## TEXAS COMMISSION ON ENVIRONMENTAL QUALITY

Re: Edwards Aquifer Protection Program, Comal County

Name of Project: Stone and Soil Depot; Located on the west side of Hwy 281, approximately 1,000 feet north of Hwy. 46; Bulverde, Texas

Type of Plan: Request for the Approval of a Contributing Zone Plan (CZP), 30 Texas Administrative Code (TAC) Chapter 213 Subchapter B Edwards Aquifer

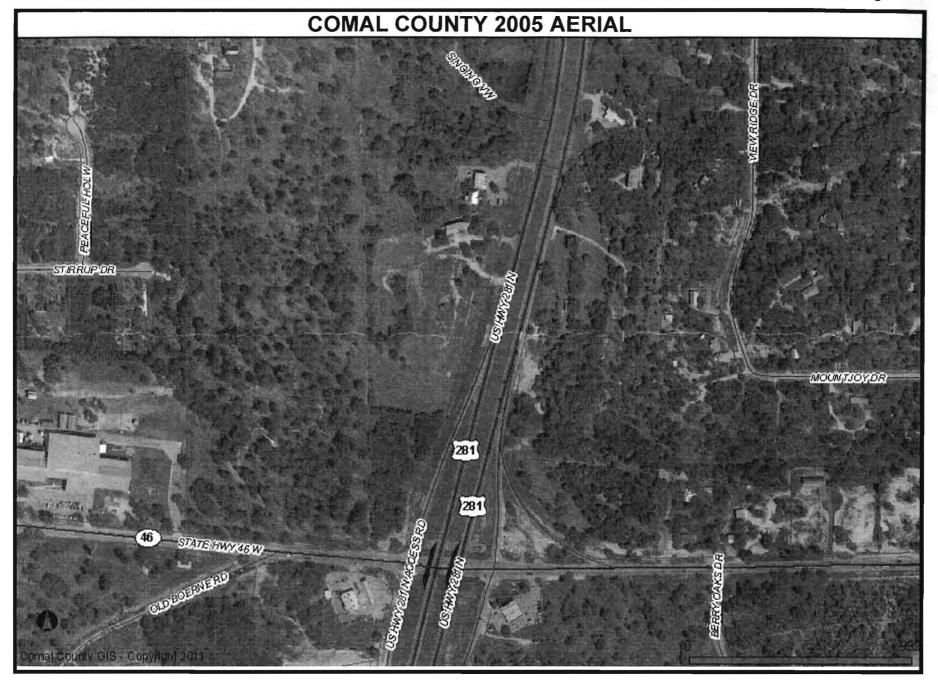
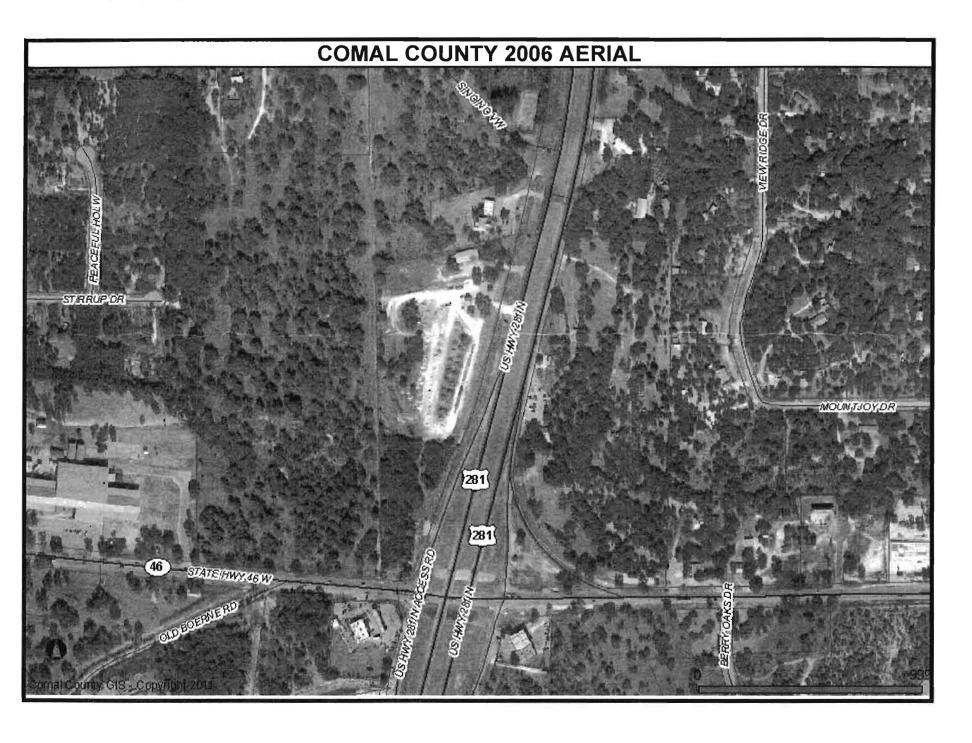
b. To prevent erosion at the outfall of the pipe, provide velocity and/or erosion controls at the discharge point.

The grate inlet discharge pipe is designed with a nominal 0.5% slope and is discharging in an existing grassy area. The discharge is not flowing across a vegetative filter, but rather parallel to and along the existing vegetative filter. Based on the low flow volumes, small drainage area, and discharge pipe slope of 0.5%, erosion at the grate inlet discharge pipe exit is not anticipated. However, to ameliorate this concern, a 3 foot by 3 foot wide area in front of the pipe discharge will be covered with 3 to 5 inch rock to act as a velocity dissipater and erosion control mechanism as illustrated on Exhibit 1.
